DOCUMENT 00 90 00
ADDENDUM

ADDENDUM: 1

DATE: APRIL 14, 2025

PROJECT: IOWA-GRANT SCHOOL DISTRICT
LOCKER ROOM RENOVATION
462 IOWA GRANT ROAD
LIVINGSTON, WISCONSIN 53554
PROJECT NO. 25007

**IOWA-GRANT SCHOOL DISTRICT
LOCKER ROOM LAYOUT
FIRST FLOOR AG PLUMBING DEMO PLANS**

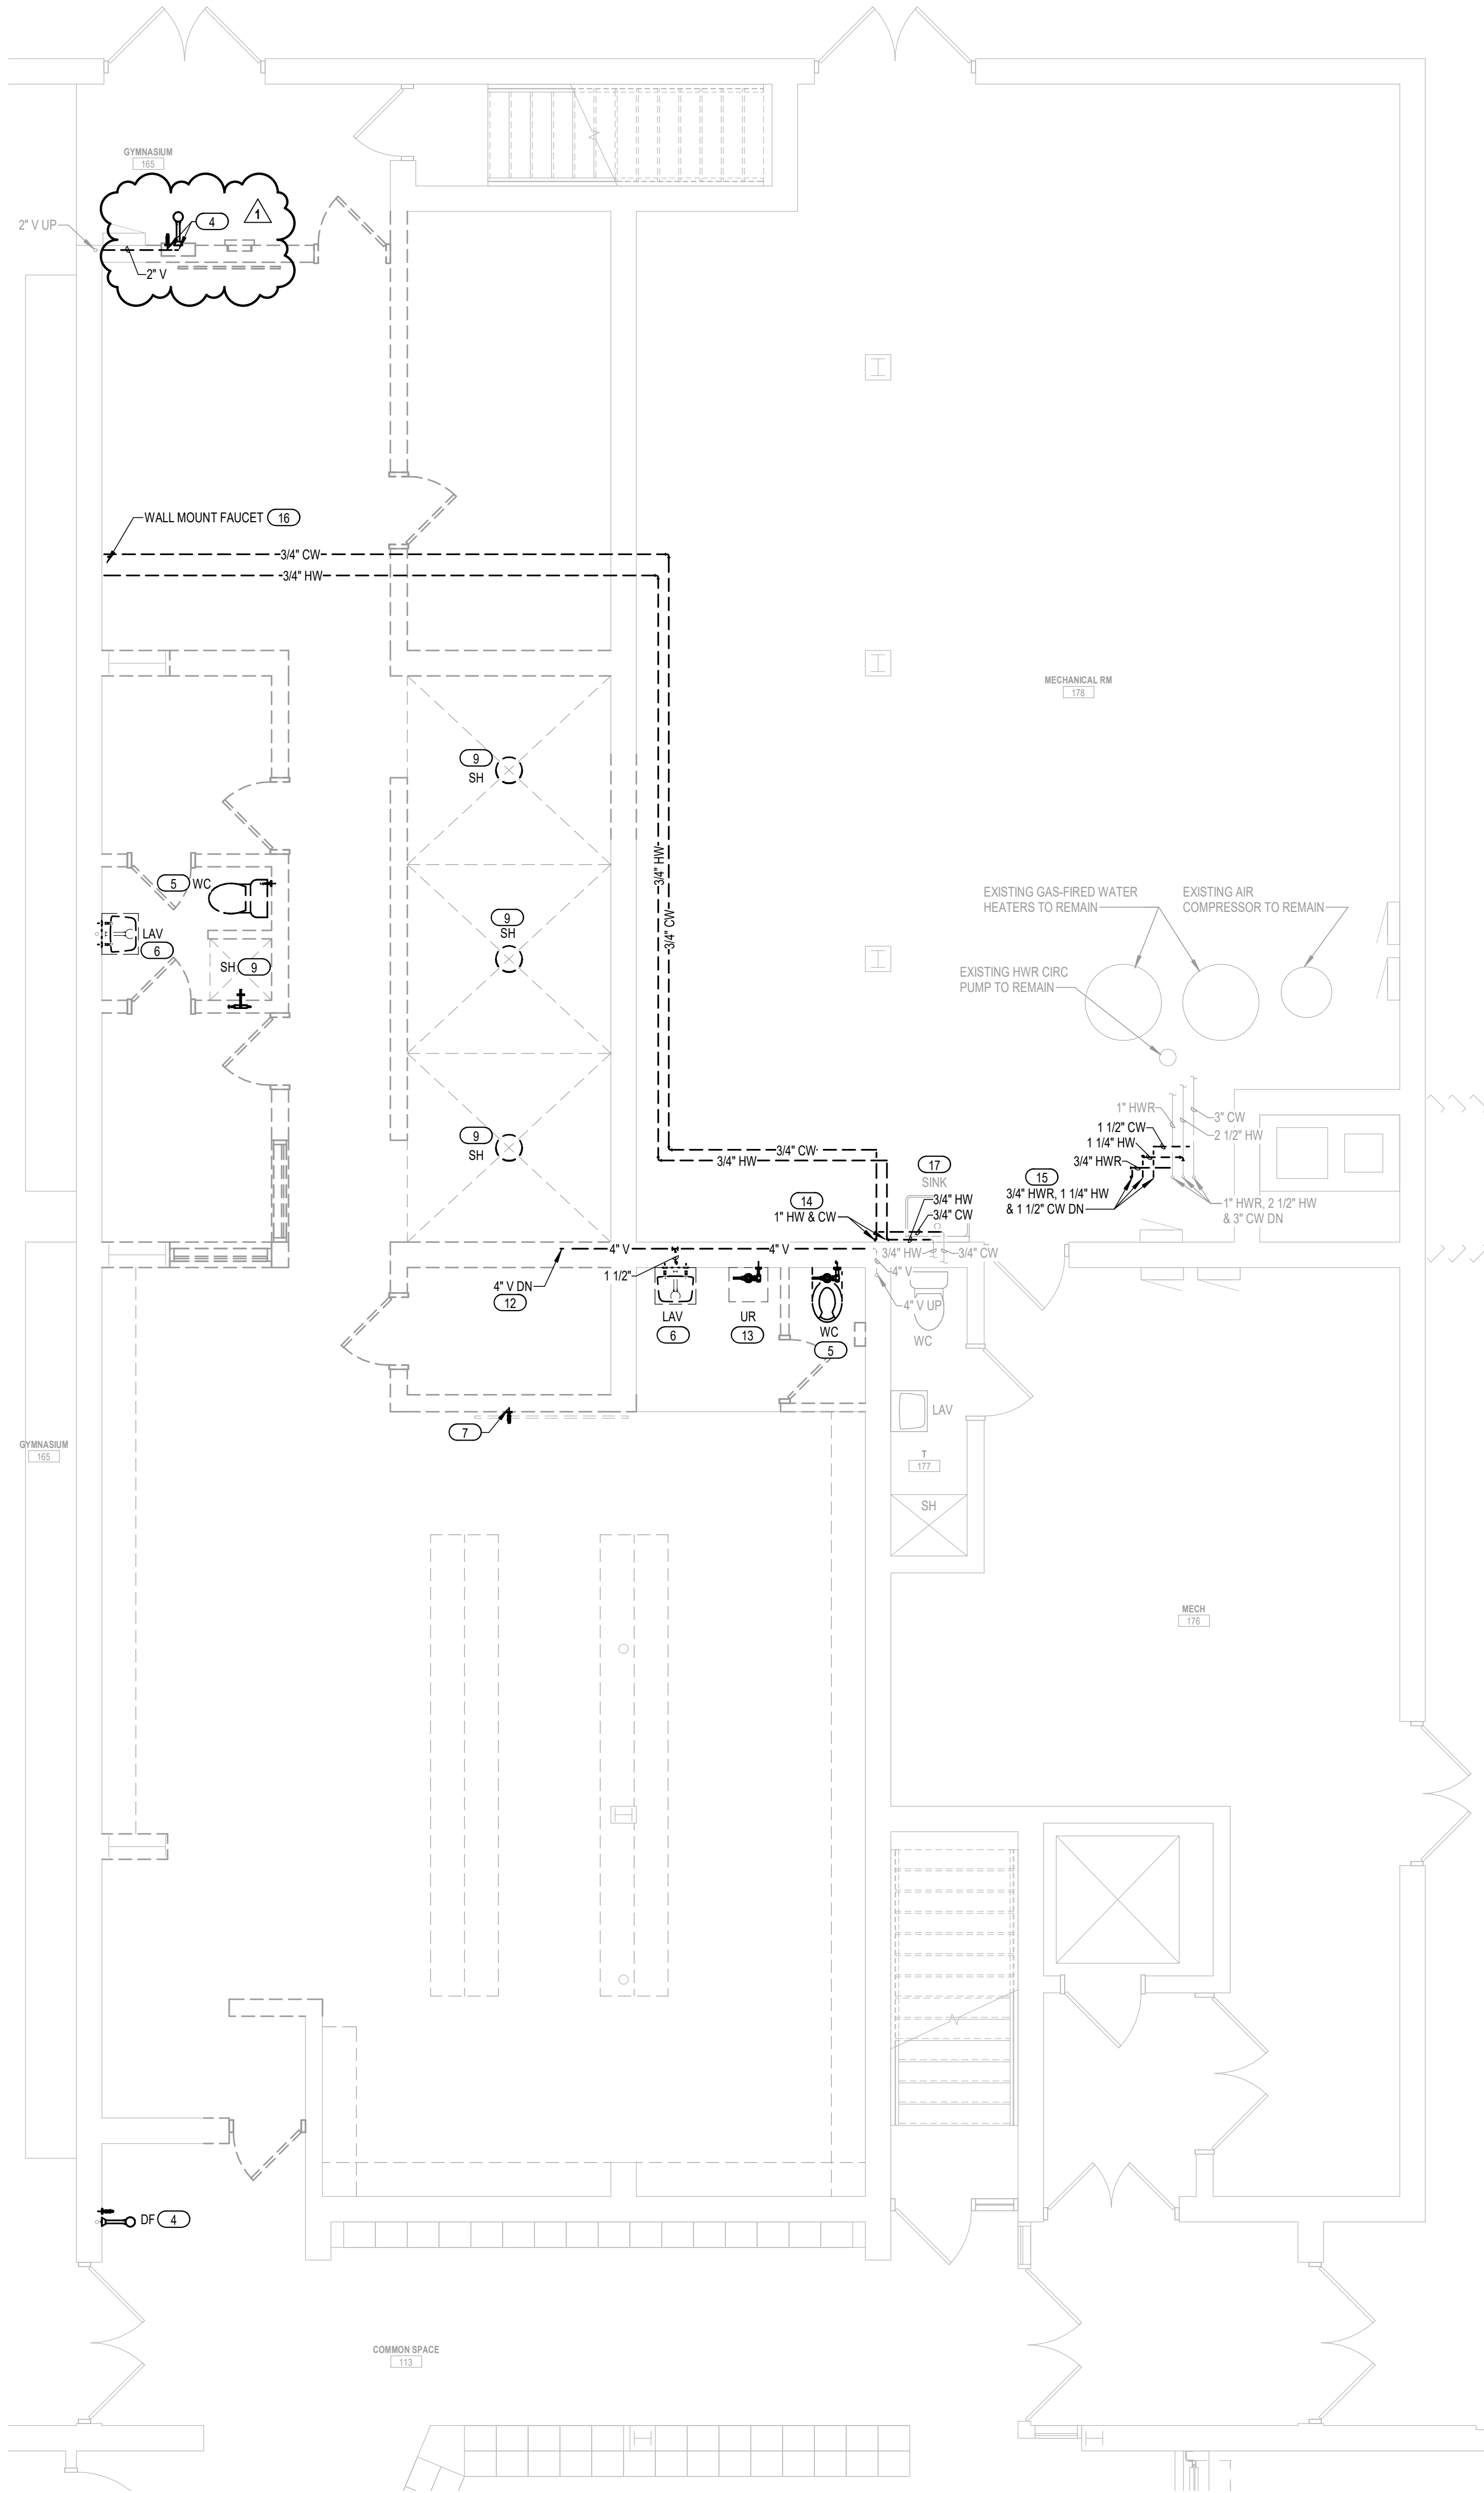
9. Sheet PD101 FIRST FLOOR AG PLUMBING DEMO PLANS 30"x42"
 - a. See the revised sheet included in this addendum. Disregard the previous version.
 - b. Revise keyed note number for demolition instructions of existing drinking fountains.

1 FIRST FLOOR DUCTWORK DEMOLITION PLAN

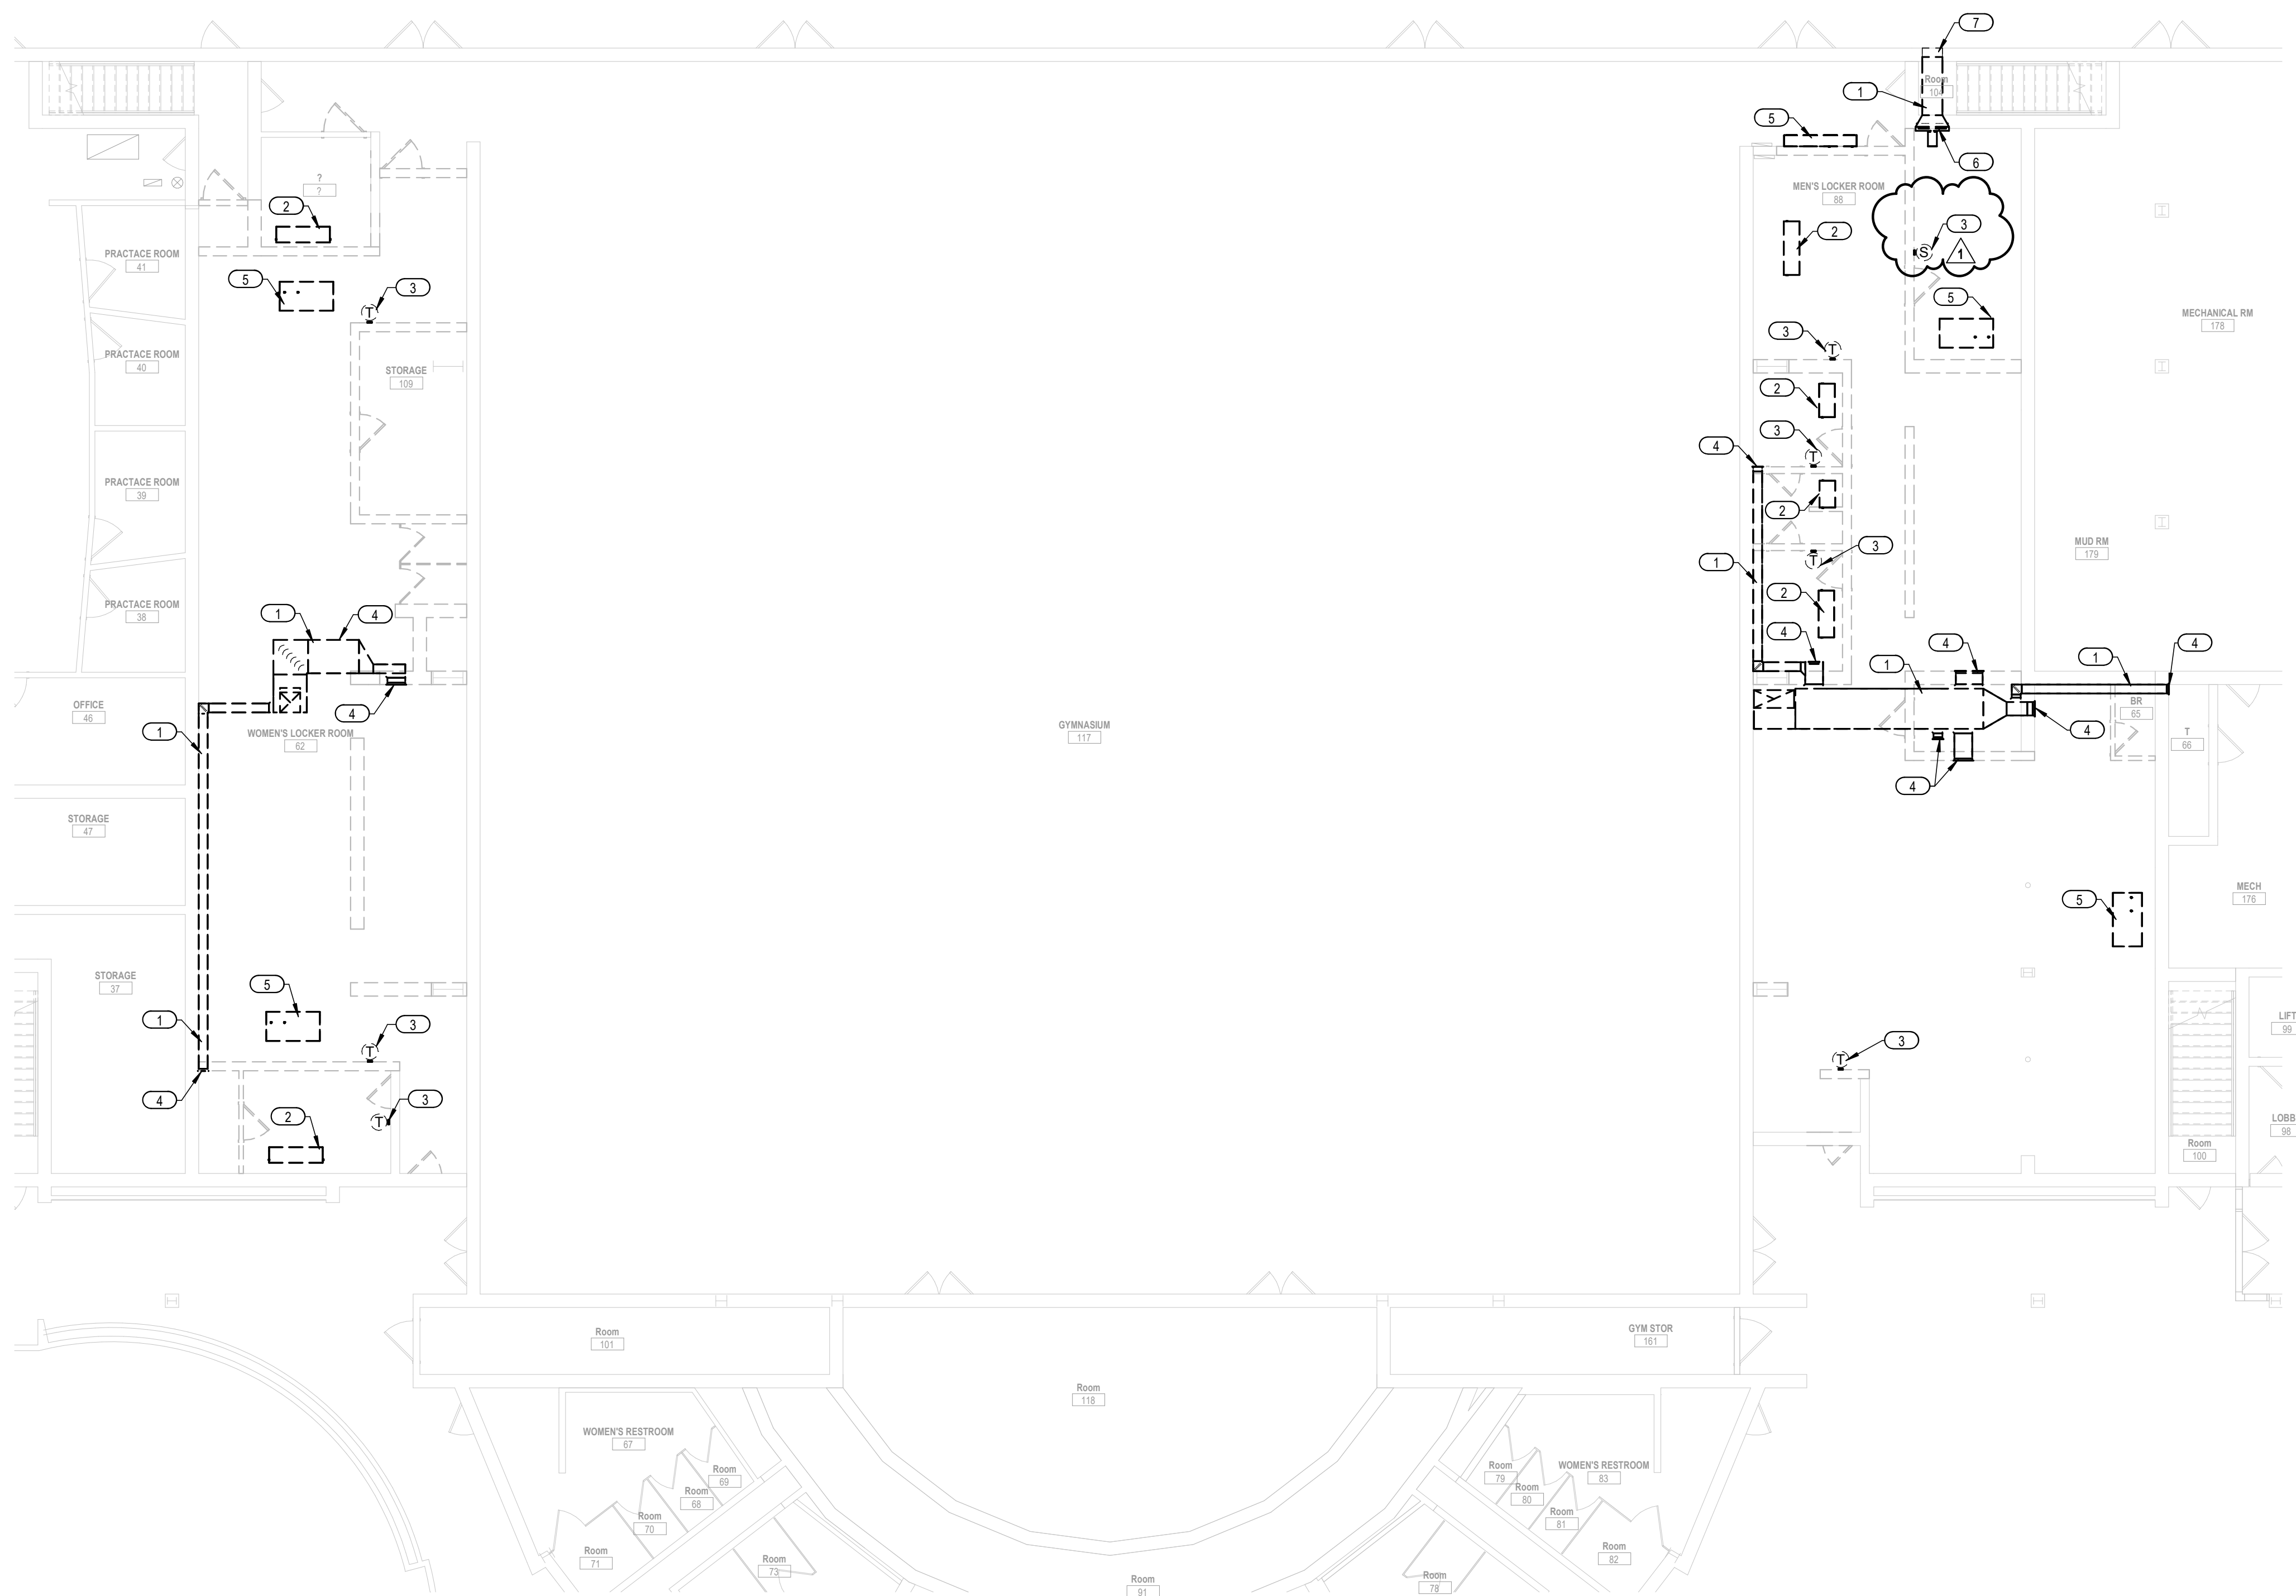
10. Sheet MD101 FIRST FLOOR DUCTWORK DEMOLITION PLAN 30"x42"
 - a. See the revised sheet included in this addendum. Disregard the previous version.
 - b. Revise to add thermostat/switch to demolition removed fan.

1 FIRST FLOOR DUCTWORK PLAN

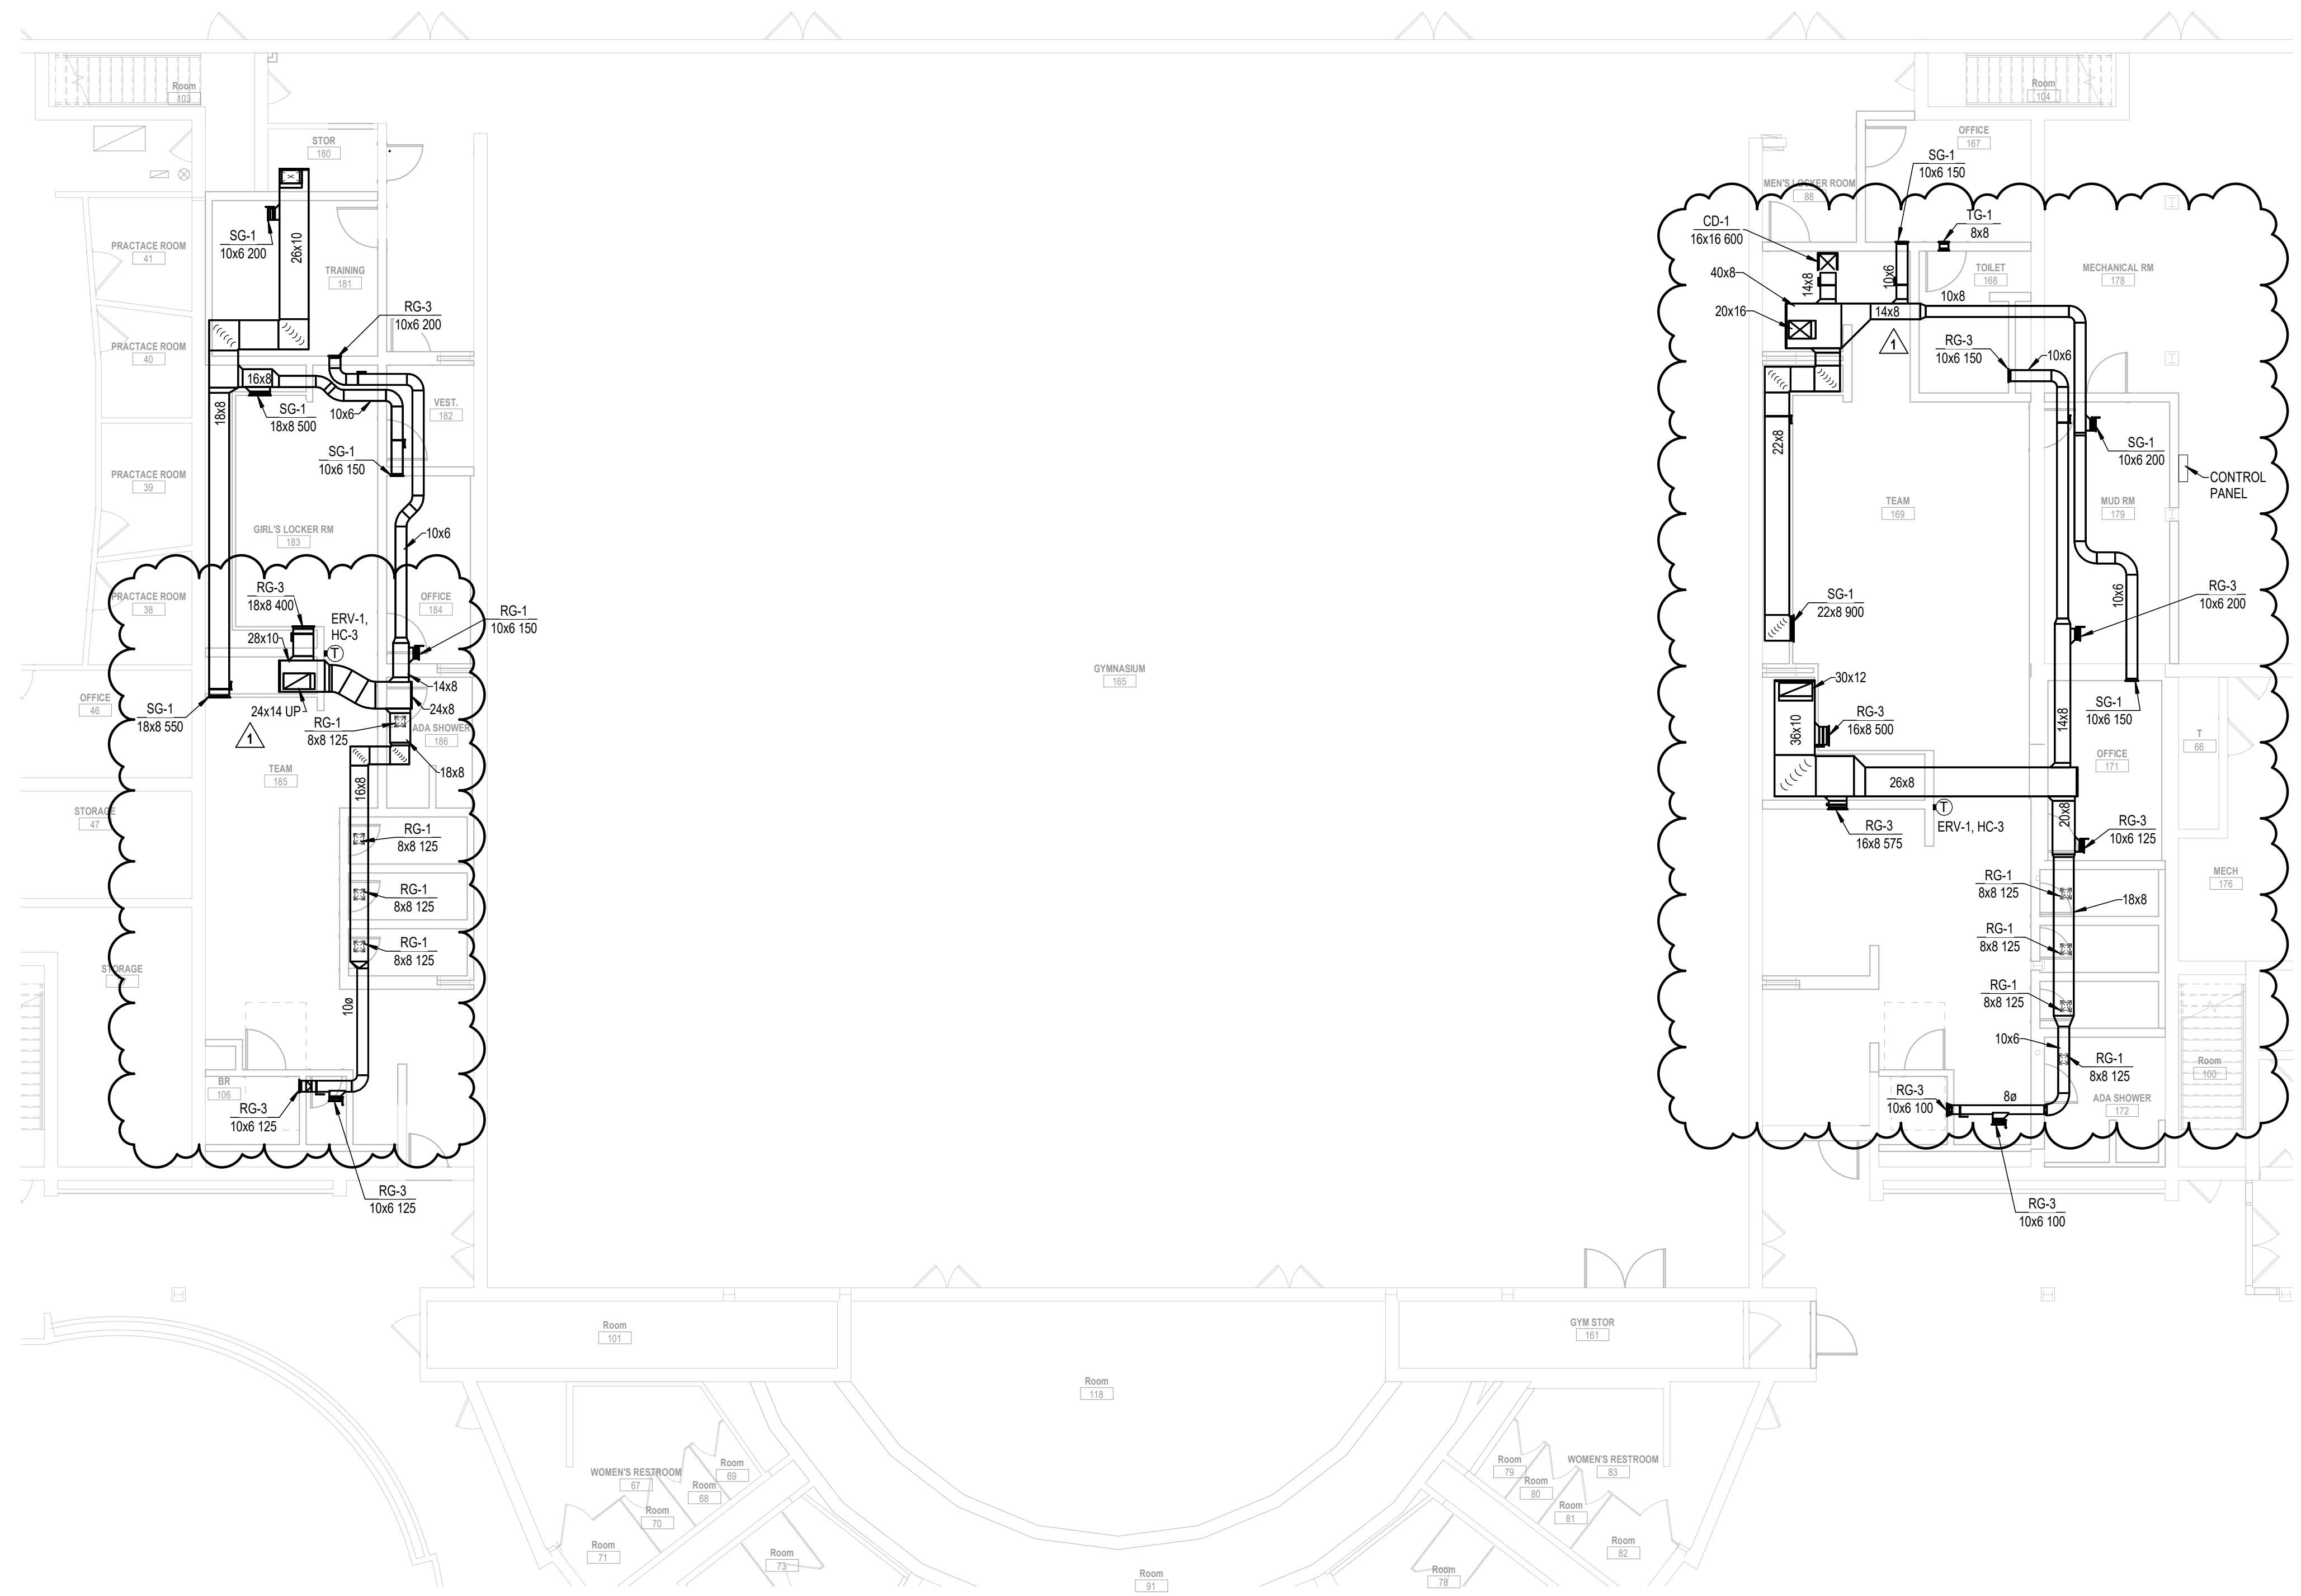
11. Sheet M101 FIRST FLOOR DUCTWORK PLAN 30"x42"
 - a. See the revised sheet included in this addendum. Disregard the previous version.
 - b. Revise ductwork sizes and layout.

- c. Revise grille locations for ERV-1 and ERV-2. Revise flows on ERV-2.
 - d. Relocate control panel for ERV-1 and AH-3 to first floor.
12. Sheet M102 SECOND FLOOR DUCTWORK PLAN 30"x42"
